DEPARTMENT OF TRANSPORTATION**Federal Aviation Administration****14 CFR Part 71**

[Docket No. FAA-2020-0988; Airspace Docket No. 18-AWA-3]

Proposed Amendment of Class C Airspace and Revocation of Class E Airspace Extension; Fort Lauderdale, FL

ACTION: Notice of proposed rulemaking (NPRM).

**PROPOSED MODIFICATION OF THE FORT LAUDERDALE-HOLLYWOOD
INTERNATIONAL AIRPORT CLASS C AIRSPACE AREA
(Docket Number 18-AWA-3)**

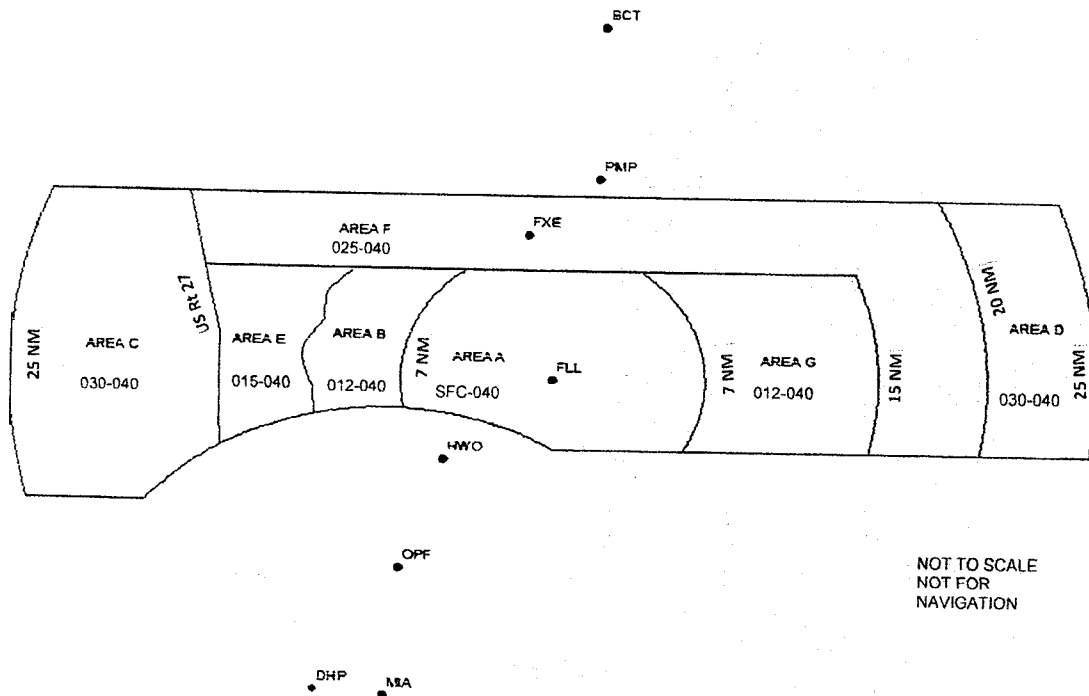
The FAA is proposing an amendment to 14 CFR part 71 to modify the FLL Class C airspace area by expanding the lateral dimensions to the east and west of the airport, and lowering of some airspace floors to enhance safety in the Fort Lauderdale terminal area (see the attached chart).

Area A. The proposed Area A is a modification of the current surface area that extends from ground level upward to 4,000 feet MSL. Area A would be expanded from the current 5 NM radius of FLL, to a 7 NM radius of the airport. It would be bounded on the north by lat. 26°10'03"N (the eastern most portion of Oakland Park Boulevard located in Lauderdale Beach); and bounded on the south by a 15 NM radius of the Miami International Airport; and on the southeast by lat. 26°00'39"N (the eastern most portion of Hollywood Boulevard located in Hollywood).

Area B. Area B, located west of Area A, would extend upward from 1,200 feet MSL to 4,000 feet MSL. It would be bounded on the north by lat.

Area C. Area C would be located at the western end of the Class C expansion. It would extend upward from 3,000 feet MSL to 4,000 feet MSL. Area C would be bounded on the north by lat. 26°13'53"N (aligned with the eastern portion of Atlantic Boulevard located in Pompano Beach) (which is also the proposed northern boundary of FLL Class C airspace area); on the west by the 25 NM radius of FLL; on the south by lat. 25°57'48"N; on the southeast by the 15 NM radius of MIA; and on the east by U.S. Route 27. Route 27 was selected as the eastern boundary based on suggestions that visual references be used to provide better situational awareness for VFR pilots.

Area D. Area D would be located at the eastern end of the Class C expansion. It would extend upward from 3,000 feet MSL to 4,000 feet MSL. It would be bounded on the north by lat. 26°13'53"N (aligned with the eastern portion of Atlantic Boulevard located in Pompano Beach); on the east by the 25 NM radius of FLL; on the south by lat. 26°00'39"N (the eastern most portion of Hollywood Boulevard located in Hollywood); and on the west by the 20 NM radius of FLL. Area D would form the eastern most section of the proposed FLL Class C airspace area. In the original design, the Class C floor in Area D was proposed to be 2,500 feet MSL. To accommodate concerns, the proposed floor is raised to 3,000 feet MSL to give VFR pilots a little more room to transition beneath the area.

Area E. Area E would extend upward from 1,500 feet MSL to 4,000 feet MSL. It would be bounded on the north by lat. 26°10'03"N (the eastern most portion of Oakland Park Boulevard located in Lauderdale Beach); on the east by the north-south portion of Interstate I-75 and State Road 869/Sawgrass Expressway; on the south by the 15 NM radius of MIA; and on the west by U.S. Route 27. Area E would be located between Areas B and C.

Area F. Area F would extend upward from 2,500 feet MSL to 4,000 feet MSL. The area's boundaries would begin at a point northwest of FLL where U.S. Route 27 intersects lat. 26°13'53"N (aligned with the eastern portion of Atlantic Boulevard in Pompano Beach); thence moving east along lat. 26°13'53"N to a point that intersects the 20 NM radius of FLL; thence moving clockwise along the 20 NM radius of FLL to a point that intersects lat. 26°00'39"N; (the eastern most portion of Hollywood Boulevard located in Hollywood); thence moving west along lat. 26°00'39"N to a point that intersects the 15 NM radius of FLL; thence moving counter-clockwise along the 15 NM radius of FLL to a point that intersects lat. 26°10'03"N (the eastern most portion of Oakland Park Boulevard located in Lauderdale Beach); thence moving west along lat. 26°10'03"N to a point that intersects U.S. route 27; thence moving north along U.S. Route 27 to the point of beginning. Area F forms the northern shelf of the FLL Class C airspace area, running east and west between areas C and D, as well as a north/south segment running between Areas G and D.

Area G. Area G would extend upward from 1,200 feet MSL to 4,000 feet MSL. The area boundaries would begin at a point northeast of FLL where the 7 NM radius of FLL intersects lat. 26°10'03"N (the eastern most portion of Oakland Park Boulevard located in Lauderdale beach); thence moving clockwise along the 7 NM radius of FLL to a point that intersects lat. 26°00'39"N (the eastern most portion of Hollywood Boulevard located in Hollywood); thence moving east along lat. 26°00'39"N to a point that intersects the 15 NM radius of FLL; thence moving counterclockwise along the 15 NM radius of FLL to a point that intersects lat. 26°10'03"N; thence moving west along lat. 26°10'03"N, to the point of beginning. Area G would be located between Areas A and F.

In addition, this action proposes to remove the Class E airspace extension to the FLL Class C airspace surface area (which would become Class C within Area A). The proposed expansion of Area A from the current 5 NM radius, to a 7 NM radius, would overlie the Class E airspace extension rendering it unnecessary.
